Re: VAI Response to Traffic Engineering Peer Review #2
Town Yard Redevelopment
Andover, Massachusetts

Vanasse & Associates, Inc. (VAI) has provided responses to comments that were raised in the April 18, 2024 *Traffic Engineering Peer Review #2* letter prepared by The Engineering Corp (TEC) concerning their review of the March 18, 2024 *VAI Response to Traffic Engineering Peer Review* letter that was been prepared by VAI in support the proposed Town Yard redevelopment to be located in Andover, Massachusetts (hereafter referred to as the “Project”). Listed below are the comments that were identified by TEC in the subject letter that pertain to the March 18, 2024 report and require a response, followed by our response on behalf of the Project proponent.

Figure SD-1B

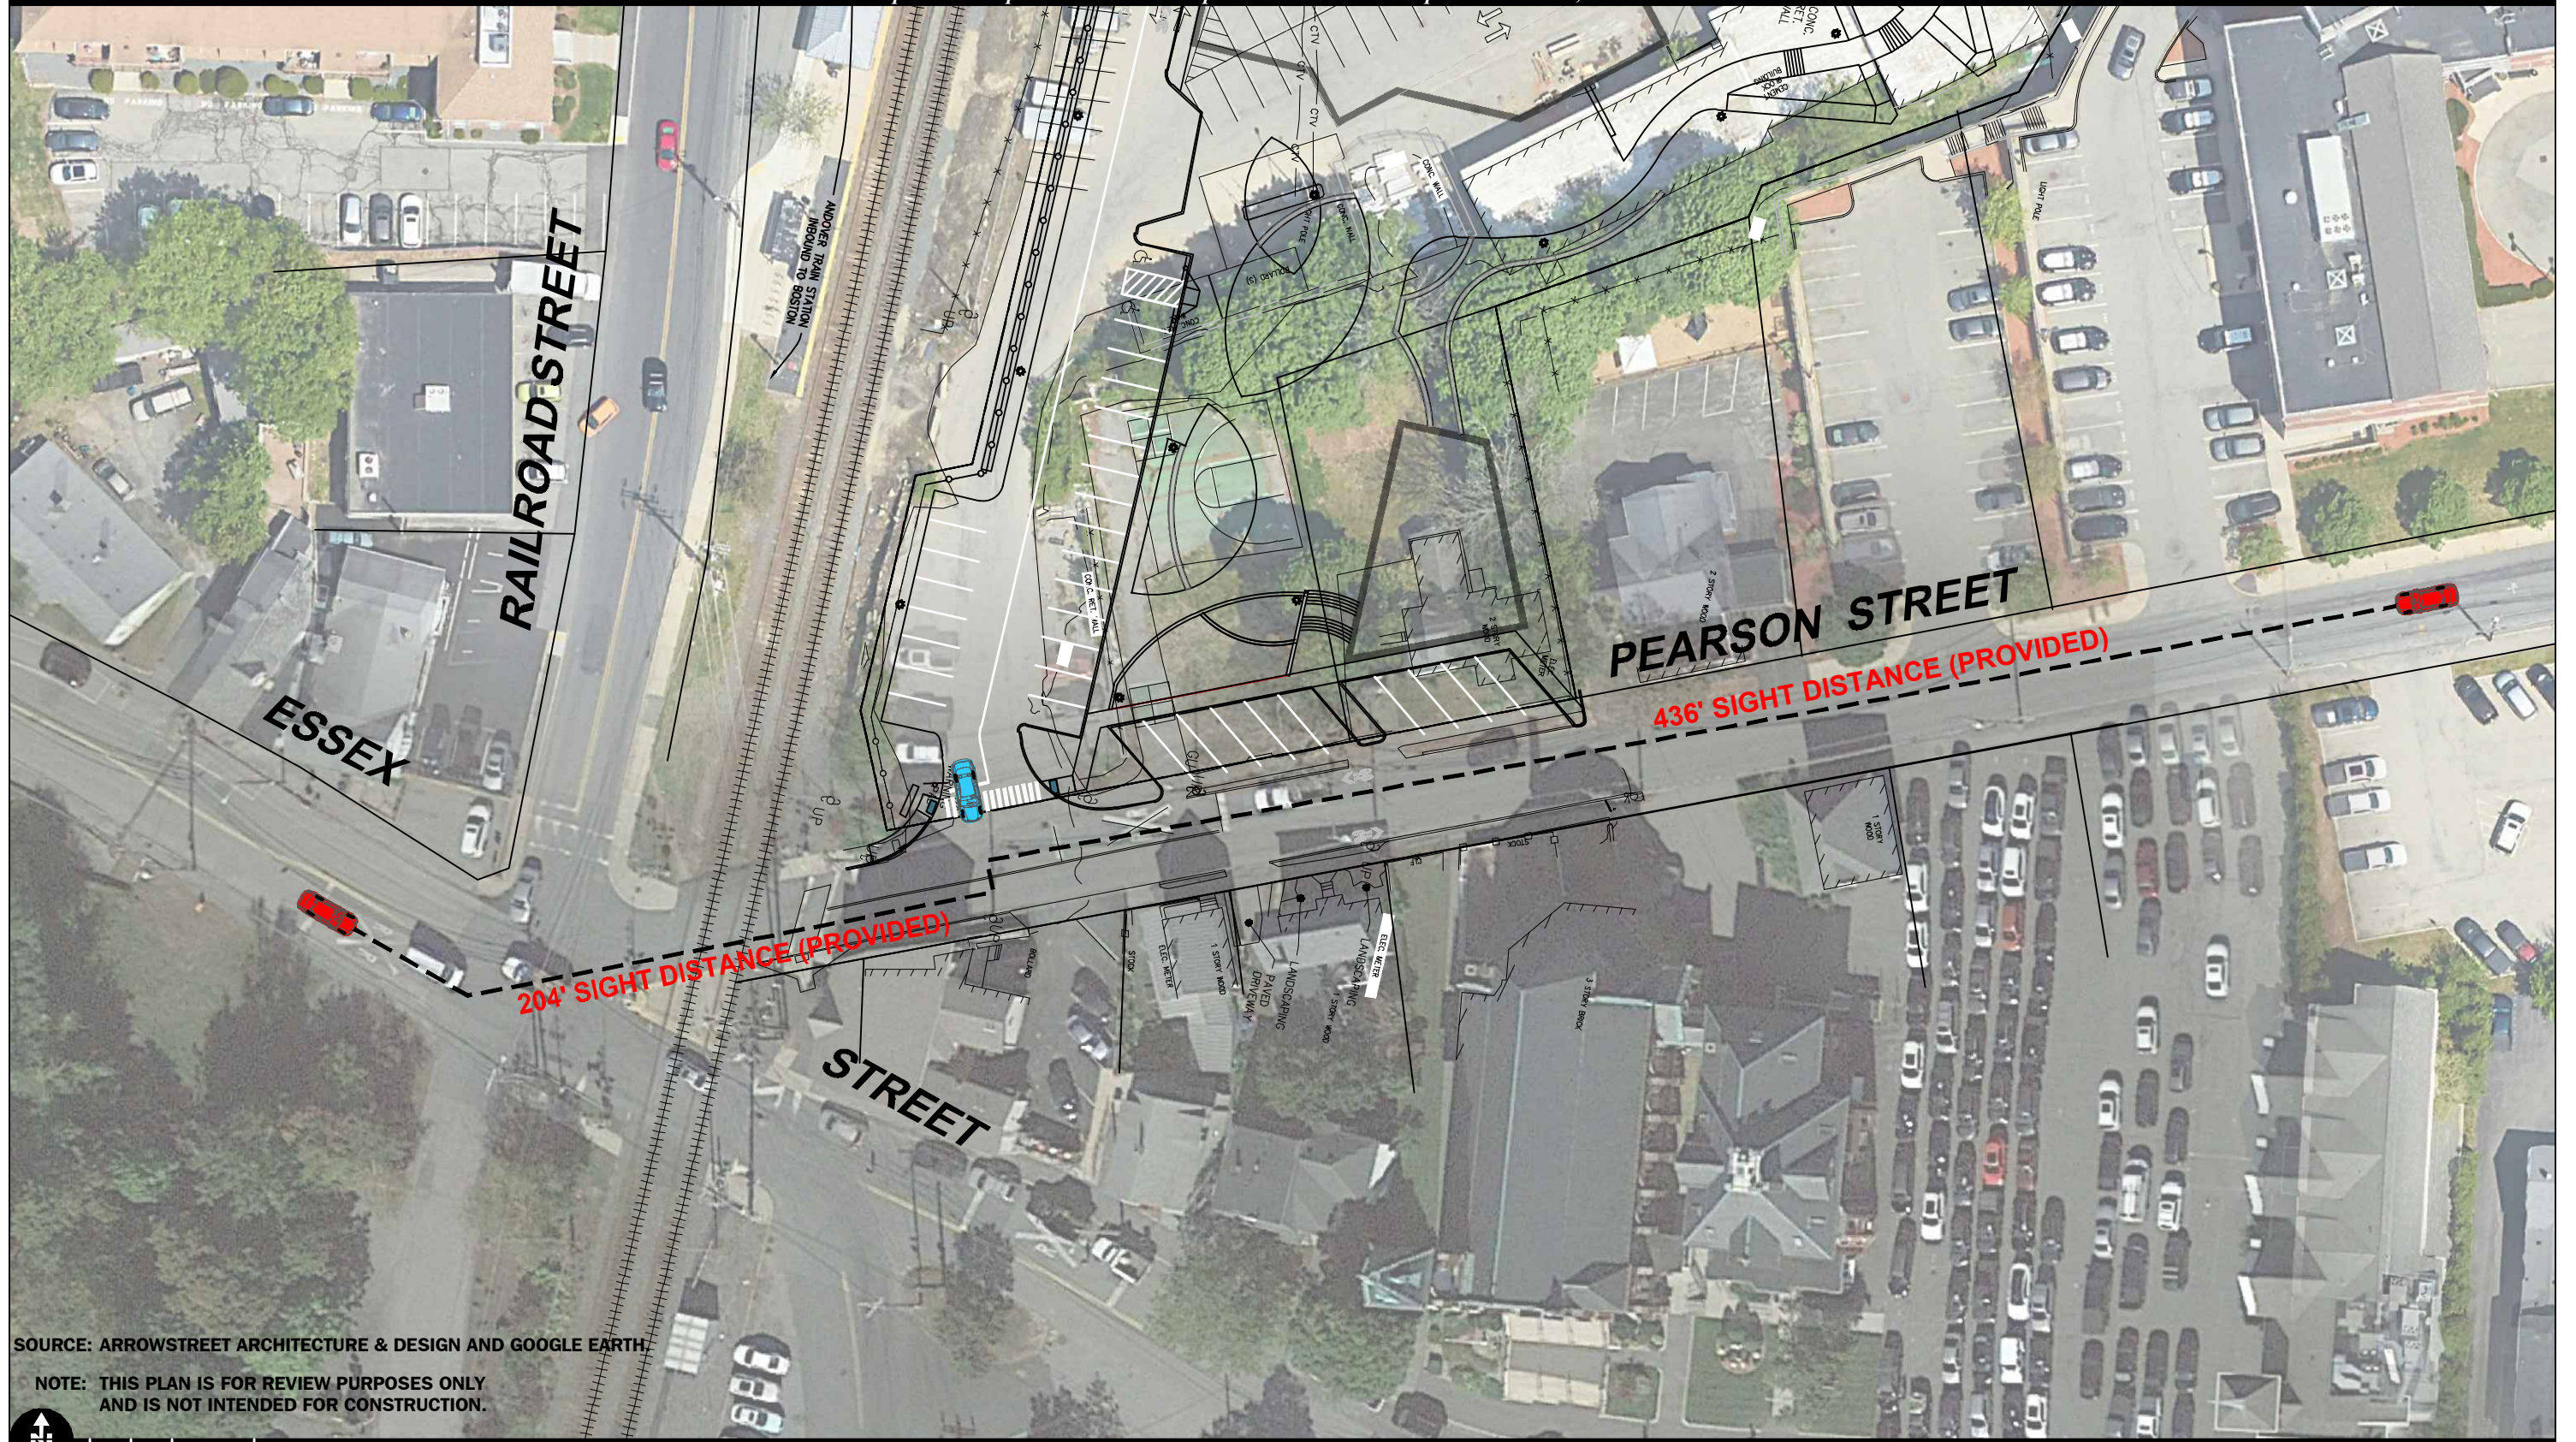
Comment 13: *The Applicant has provided stopping sight distance (SSD) and intersection sight distance (ISD) measurements for the Site Driveway along Pearson Street. The results are shown in Table 8 of the TIA and have been compared to recommended values obtained from A Policy on Geometric Design of Highways and Streets, 7th Edition, American Association of State Highway and Transportation Officials (AASHTO), 2018. The measured distances have been shown in the TIA to exceed these values, except for the ISD for vehicles looking west while exiting the site (111 feet). However, Table 8 contains notes stating that three of the four measured distances have been determined if parked cars to the east were removed and if a hedge to the west were cut. The fourth measured distance of 241 feet (SSD approaching from the west) is questionable since Pearson Street is roughly 100 feet from its intersection with Essex Street to the site driveway. A distance of 241 feet could only be attained by measuring further west along Essex Street, which places the limit about 150 feet from the railroad tracks. At this point, the sight distance is further affected by a concrete retaining wall in the parking area of Ann's Cleaners at #2 Railroad Street, as well as a railroad signal gate and utility poles on Pearson Street near the proposed site driveway. The Applicant should provide a graphical depiction, preferably in the form of a sight triangle sheet in the site plans, of the sight lines for this driveway. Sight lines to the east along Pearson Street should not cross over the head-in parking stalls proposed along the northerly side of the roadway.*

TEC Response: *TEC acknowledges the sight line graphic SD-1 provided; however, the Applicant has not addressed sight line related items towards the west or the tracks in the above comment. TEC acknowledges that these sight lines may be moot based on the Mass Works project; however, there is no guarantee that the project will be completed even if funded.*

VAI Response: See updated Figures SD-1A and SD-1B in the Appendix to this letter depicting sight distances east and west of the driveway assuming Pearson Street remains continuous to Essex Street.
